Staff Report & Recommendation

Historic Preservation Board

SUBJECT: HPB23-0591, **1509 and 1515 Washington Avenue and 1500 Collins Avenue.**

The applicant has submitted plans entitled "An Iconic Hotel, Miami Beach", as prepared by Norberto Rosenstein Architect, Inc and Rottet Studio Architecture and Design, dated December 8, 2024.

Haddon Hall Hotel photograph, ca. 1941

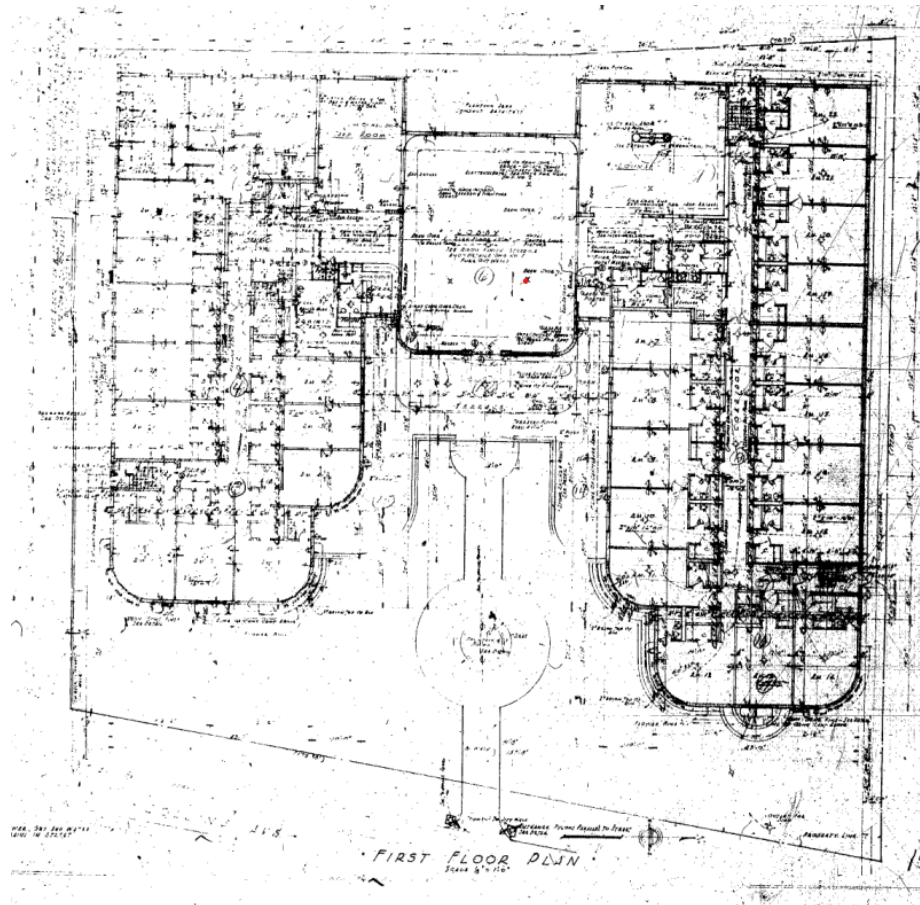
The Haddon Hall Hotel, designed by architect L. Murray Dixon and built in 1941, is an outstanding example of the Streamline Moderne style of architecture. In 2014, the Board approved the comprehensive renovation and restoration of the building, which incorporated significant improvements to the front yard area as well as the restoration of the lobby and ancillary public spaces. The applicant is proposing several significant modifications to the historic building including the following:

The applicant is proposing to retain the existing historical elements of the front yard including the two entry pylons and the circular fountain. Additionally, several areas of paving are proposed to be replaced with additional landscaping and shade trees which should enhance the overall appearance of the building. Further, new contrasting paving for the vehicular and pedestrian surfaces highlighting the original entry walkway design, is proposed. Staff would note however, that the landscape and hardscape as depicted in the renderings does not correspond to the proposed plans.
